Remarks
Of the Republic of Poland
as:
the state of registration and operator

on the draft Final Report
regarding
the investigation into the accident of the Tu-154M tail number 101 aircraft
which occurred on 10 April 2010
drafted by
the Interstate Aviation Committee (IAC)

Warsaw, 19 December 2010

1) regarding the aerodrome description contained on page 67 of the Report:

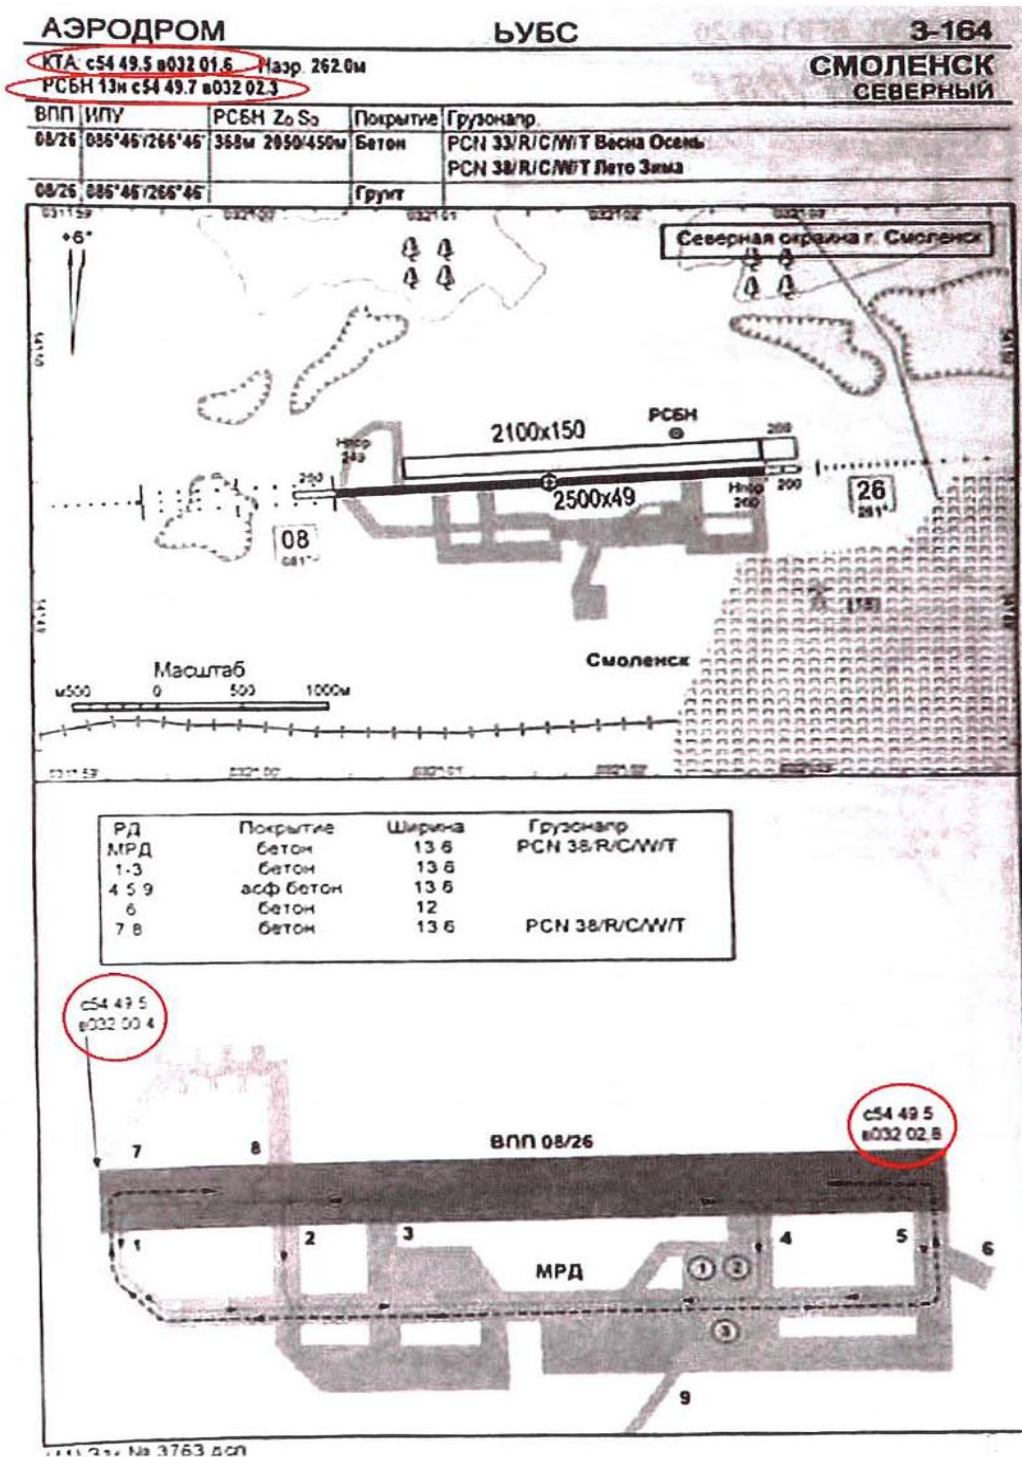
According to the Russian side, Smolensk “Severny” aerodrome met the requirements of Class 1 aerodrome (*“Technical Review Act of Smolensk “Severny” aerodrome with the purpose of special flights”* of 5 April 2010). The data provided on the aerodrome are actually unverifiable for the Polish side, due to the fact that the Russian site failed to provide source materials, including: *“Flight operation manual for the aerodrome”*, *“aerodrome Master Plan”* and/or similar documents. The Report does not provide detailed schematics of the aerodrome, the display of restricting area and the cross section along the axis of the runway as well as the approach areas surface. The Russian side failed to provide the Polish side with any materials or legislation, defining the classification rules for state aviation aerodromes and military airfields requirements for each class. This prevents the Polish side from comprehensive verification whether the required parameters for class I military airfields had been ensured for Smolensk “Severny” aerodrome. This in particular regards the restricting area, which is determined for each aerodrome in order to ensure the safety of aircraft traffic operating on aerodromes and which defines the maximum allowable height for buildings and terrain objects, located in the vicinity of the aerodrome. Objects which parameters exceed the values defined by the above mentioned area should be removed, or (in case of inability to remove) should be identified as air traffic obstacles and marked accordingly.

The available information indicates that the data on the aerodrome provided to the Polish side, including the coordinates of the ARP, runway threshold coordinates and the coordinates of the outer and middle NDB aeriels (all coordinates on the approach chart), are expressed in the SK-42 coordinates system and not in currently generally accepted for aviation WGS-84 system. The Polish side was not informed about this fact by the Russian side upon submission of the approach charts by the latter.

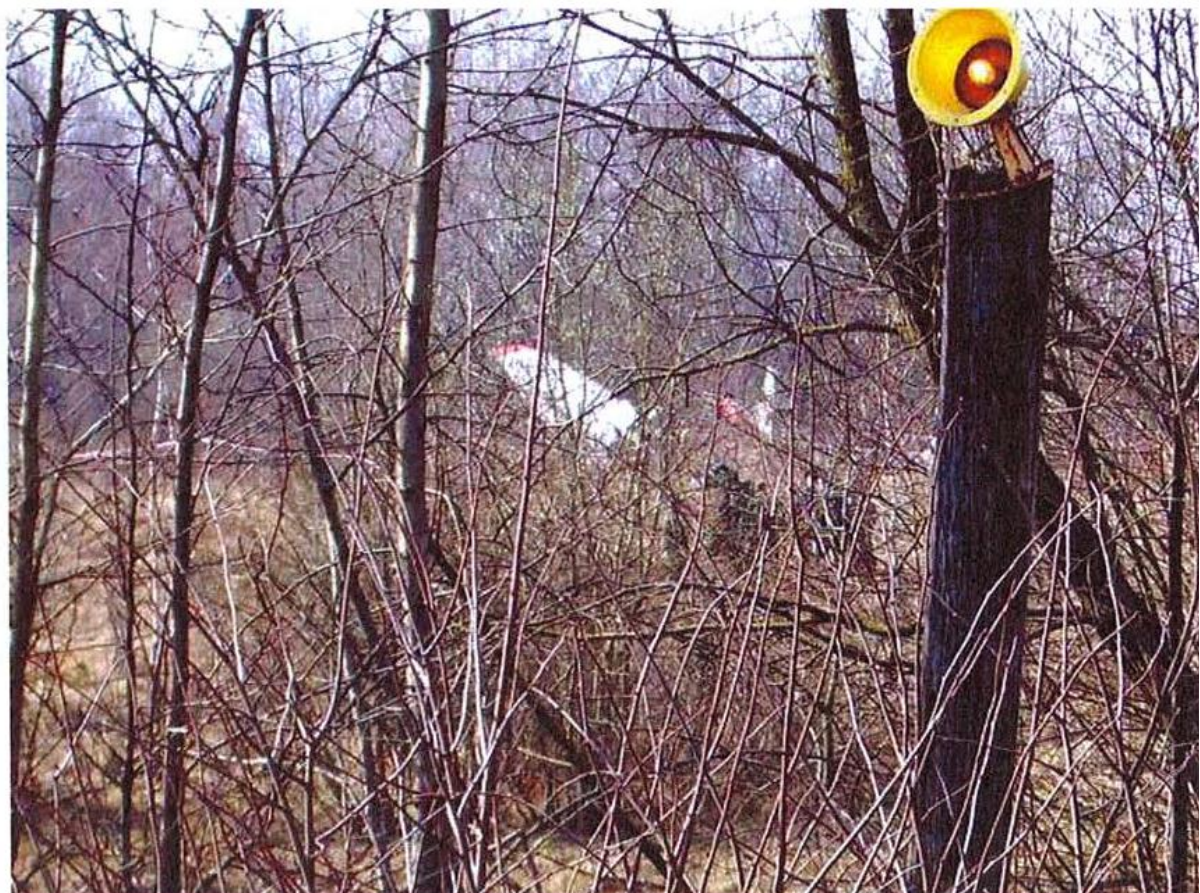
Location of the blip on the indicator corresponds to the position “on the glide path” when the permissible error of linear deviation does not exceed 1/3 of the linear dimensions of the zone of tolerance”. (in accordance with paragraph 115 of FAPPPGosA)

For the path of 3°10' at a distance of 3.3 km to the DS26 the permissible error of linear deviation is ± 28 m, i.e. with a tolerance of 1/3 of the value that is below - 9.33 m, KSL should have informed the crew of its wrong position on the path. The conclusion is that even before reaching 3 km, KSL continued to inform the crew of their correct position “on the course and path”, when in fact the flight of the aircraft was lowering, increasing its vertical distance from the path.

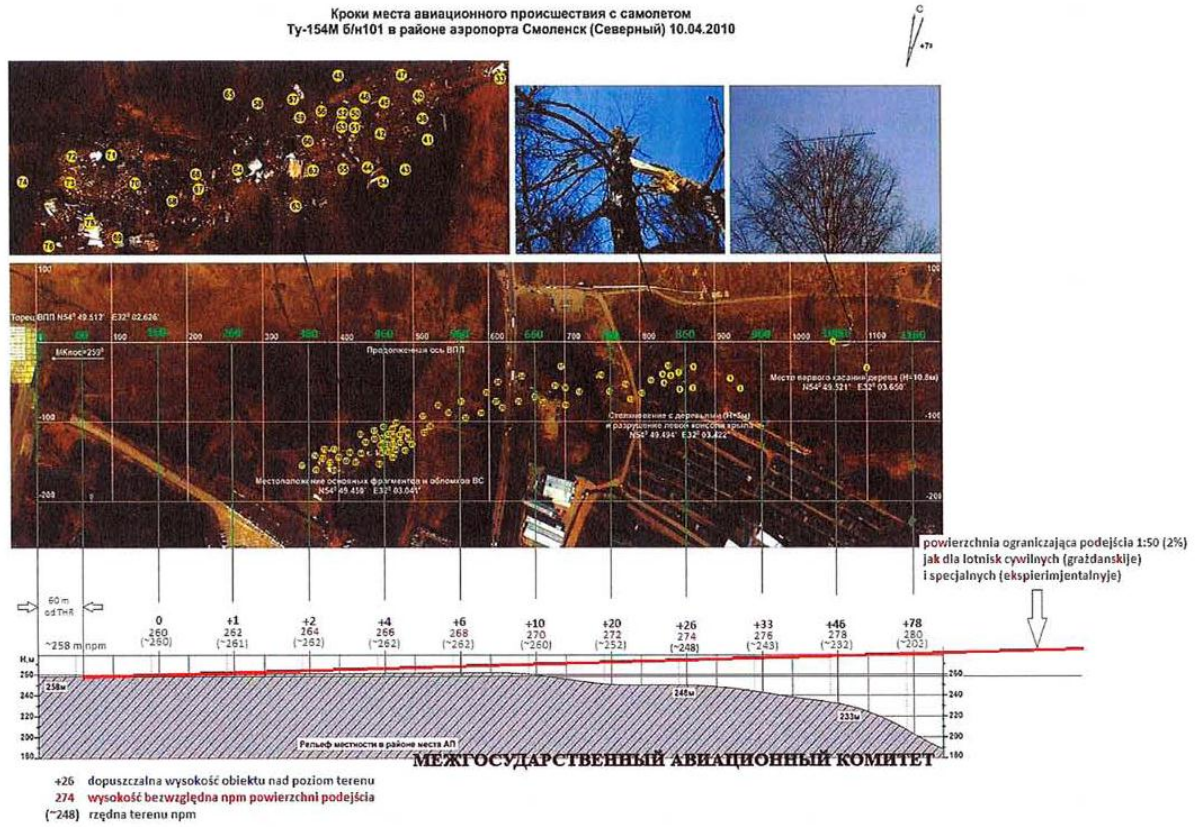
Initial data of the approach surface:

- surface stretching 60 m from the 26 threshold;
- width of initial (internal) margin 300 m (150 m from the DS axis);
- separation of side margins 15% (app. 8.5°);
- slope 1:50 (2%);
- initial ordinate 258 m above sea level (height of 26 threshold).

Trees and shrubs app. 500 m from the DS 26 threshold (view toward 259° approach)

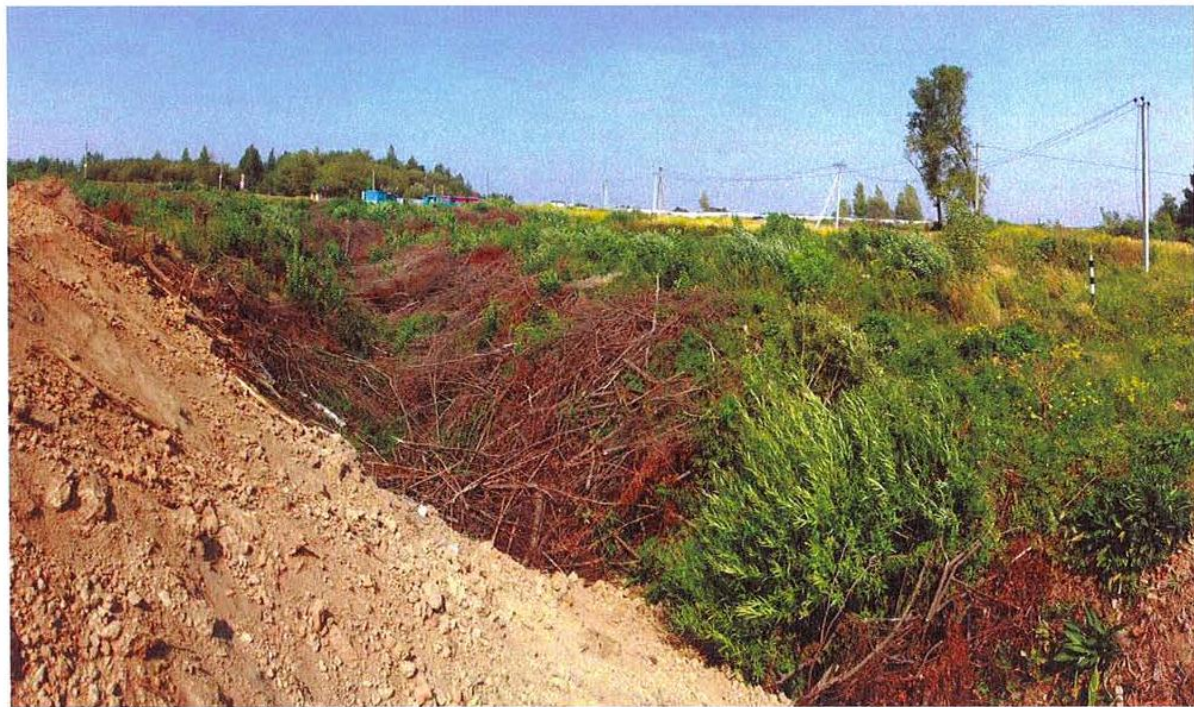
In both options, it was found that the area situated at a 300 m to 850-900 m distance from the DS 26 threshold, within the approach limiting surface from the 259° direction, was overgrown with plenty of shrubs and featured clusters (groups) of trees of a height of the order of 20 - 25 m above ground level, which exceeded (sometimes significantly, by approximately up to 15 m) the maximum admissible height of objects set by the above stated limiting surface, particularly in the area of the motorway intersecting the approach (400 m -700 m from the DS 26 threshold).

This is inconsistent with the Polish, Russian and ICAO (Annex 14) regulations. These clusters of trees in question constituted a real threat to aircraft approaching for landing on the DS 26, especially in the difficult weather conditions that prevailed on 10 April 2010. Moreover, the trees and shrubs growing in the area before the DS 26 threshold obscured lights from the lighting system for the crews and limited SKL personnel's already obstructed visibility (due to fog) from SKL toward the 259° approach. In these circumstances, one cannot claim the aerodrome was fully operational and ready to accept aircraft, particularly those of HEAD status. It should be noted, that *"The act of technical review of the Smolensk "Severny" aerodrome to accept special flights"* dated on 5.04.2010, merely states that, quote: *"... at a distance of 1 to 4 km from the runway threshold, there are no obstacles measuring over 10 m in height relative to the runway threshold and from 4 km to the end of the approach strip, measuring 50 m relative to the runway threshold"*. No information is given about any possible obstacles situated at a distance of up to 1 km from the DS 26 threshold, i.e. in the area where representatives of the Polish side had found clusters of tall trees. The Polish side's assessment of the forest stand having exceeded permissible height levels along the DS 26 approach is confirmed by the mass logging of trees and shrubs in that area, which took place after the accident, as had been established based on the available photo documentation (picture below).
